Access Compliance Report

Public Rights-of-Way

(Curb Ramps)

Intersection ID: 10040925	Main Street: WALLACE_RD	Cross Street: N/A	Location: SW
ADA ID: F8A7EFEF96AF	Ramp Type: PerpDiag	Initial Pass/Fail: Fail	Overall Compliance: No
		Severity Score: 35

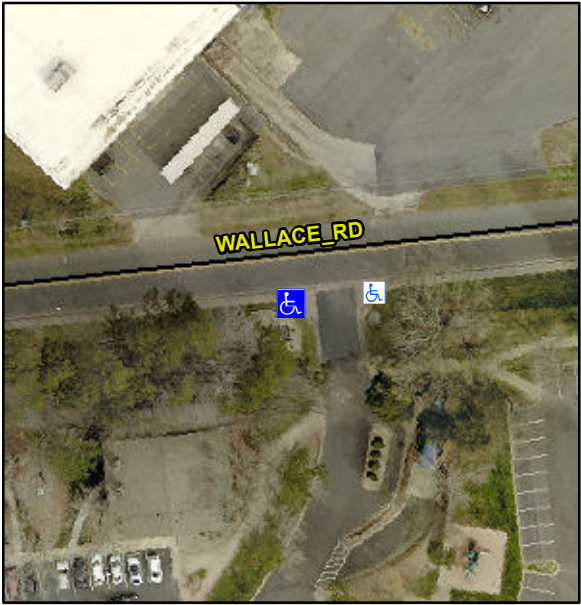
Codes/Mitigation Info/Possible Solution			Field Measurements/Component Compliance		
	Possible Solutions:		Compliance	Description	Data
	Remove & Replace Curb Ramp With Two New Directional Ramps or Equivalent.		No	Ramp Length (in)	48.0
			No	Ramp Width (in)	45.0
			N/A	Flare Type LT	N/A
			N/A	Flare Slope LT (%)	N/A
			N/A	Flare Traversable LT?	N/A
			N/A	Landing Length (in)	N/A
			N/A	Landing Width (in)	N/A
			N/A	Landing Slope (%)	N/A
			N/A	Landing X Slope (%)	N/A
<p>Surveyor Notes:</p> <p>N/A</p> <p>PROW/ADA:</p> <p>R304.5.1, R304.2.2, R304.5.3</p>			N/A	Flare Type RT	N/A
			N/A	Flare Slope RT (%)	N/A
			N/A	Flare Traversable RT?	N/A
			N/A	DWS Provided?	N/A
			N/A	DWS Contrast?	N/A
			N/A	DWS Length (in)	N/A
			N/A	DWS Full Width?	N/A
			N/A	DWS Offset (in)	N/A
			N/A	Gutter Ponding?	N/A
			N/A	Gutter Lip Ht (in)	N/A
<p>Street 1 Name</p> <p>ENTRANCE</p> <p>Stop Condition-Street 2</p> <p>StopSign</p> <p>Street 2 Name</p> <p>WALLACE RD</p> <p>Stop Condition-Street 1</p> <p>None</p>			No	Painted X Walk1?	No

To E	X Walk 1 Direction	To E
			N/A	X Walk 1 Width (in)	N/A
			0.2	X Walk 1 Slope (%)	4.7
			5.3	X Walk 1 X Slope (%)	2.3
			N/A	Ramp inside XWalk1?	N/A

2.3	Road Slope (%)	N/A
			7.2	Road X Slope (%)	N/A
			N/A	Any Obstructions?	N/A
				Obstruction Type	
<p>Total Cost:</p> <p>\$ 3200.00</p>			N/A	Storm Grate/Utility Hazard?	N/A
				Storm Grate/Utility Type	
			N/A		N/A
			Yes	Surface Condition? (G/P)	Good
